MIL-M-38510/26(USAF)
AMENDMENT 5
18 December 1995
SUPERSEDING
AMENDMENT 4
17 June 1976

MICROCIRCUITS, DIGITAL, TTL, LOW POWER,
EXCLUSIVE-OR GATES, MONOLITHIC SILICON

This amendment forms a part of Military Specification
MIL-M-38510/26(USAF), dated 15 August 1972.

NOTE: All resistance values are nominal.
FIGURE 3. Schematic circuit - circuit B.

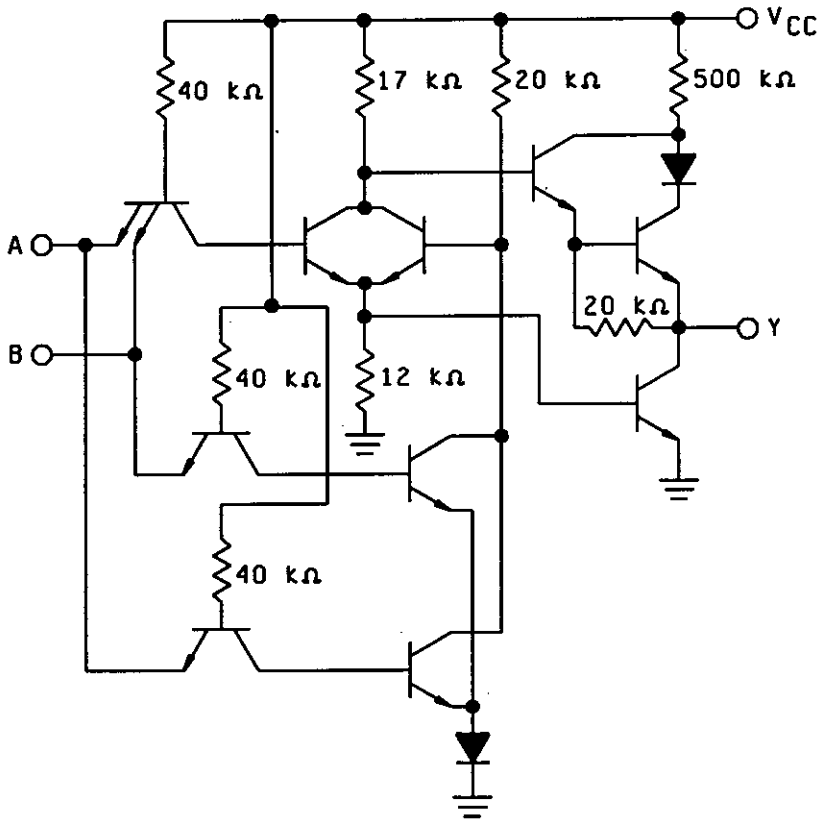
FIGURE 3, schematic circuit: Add "circuit: Add "circuit A" after schematic circuit; add new circuit (B) as shown on page 3 of this amendment.

FIGURE 5. Switching time test circuit.

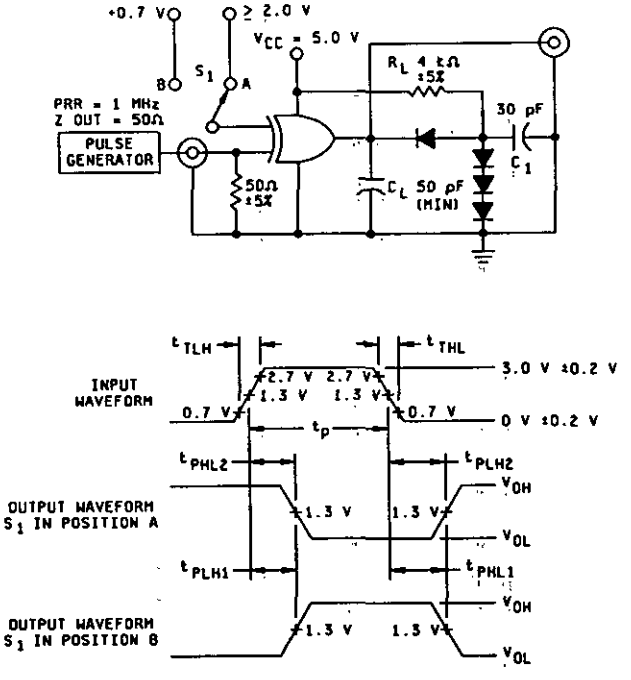
FIGURE 5, switching time test circuit: Delete and substitute figure 5 as shown on page 4 of this amendment.
